LIMERICK GENERATING STATION, UNIT 1

AMENDMENT TO FACILITY OPERATING LICENSE

Amendment No. 34
License No. NPF-39

ATTACHMENT TO LICENSE AMENDMENT NO. 34

FIGURE 3.3.6-1

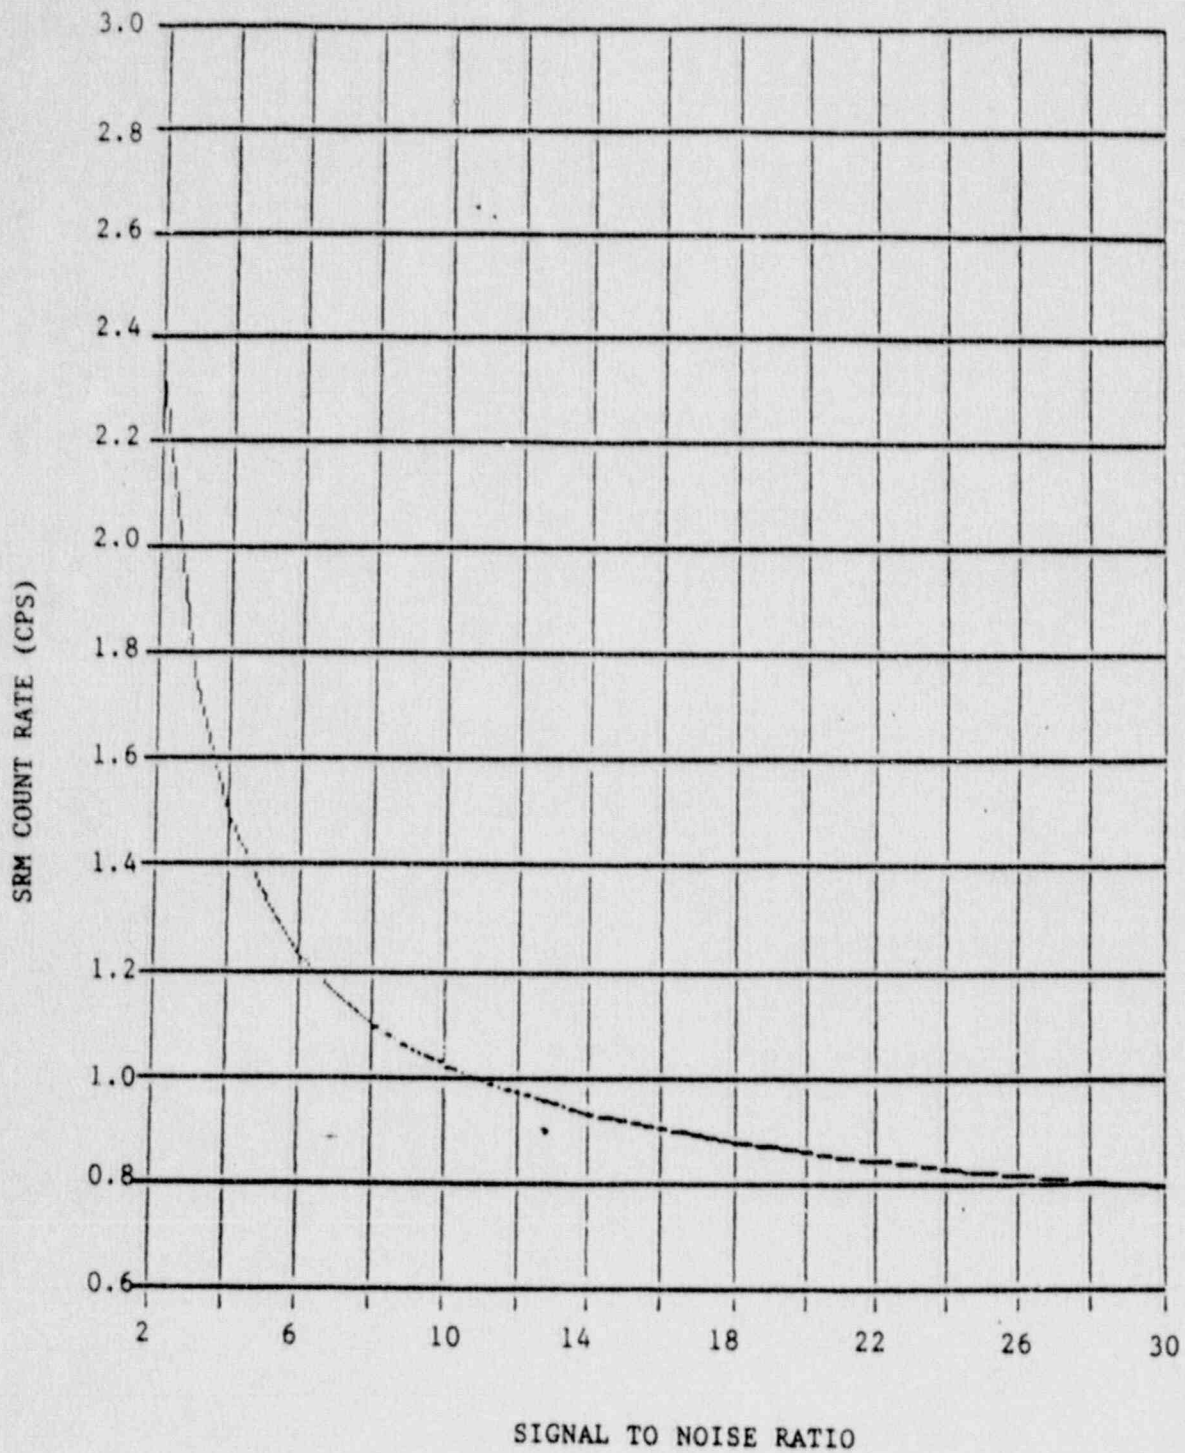
**May be reduced provided the Source Range Monitor has an observed count rate and signal-to-noise ratio on or above the curve shown in Figure 3.3.6-1.

***May be reduced, provided the source range monitor has an observed count rate and signal-to-noise ratio on or above the curve shown in Figure 3.3.6-1.

*May be reduced, provided the source range monitor has an observed count rate and signal-to-noise ratio on or above the curve shown in Figure 3.3.6-1. These channels are not required when sixteen or fewer fuel assemblies, adjacent to the SRMs, are in the core.
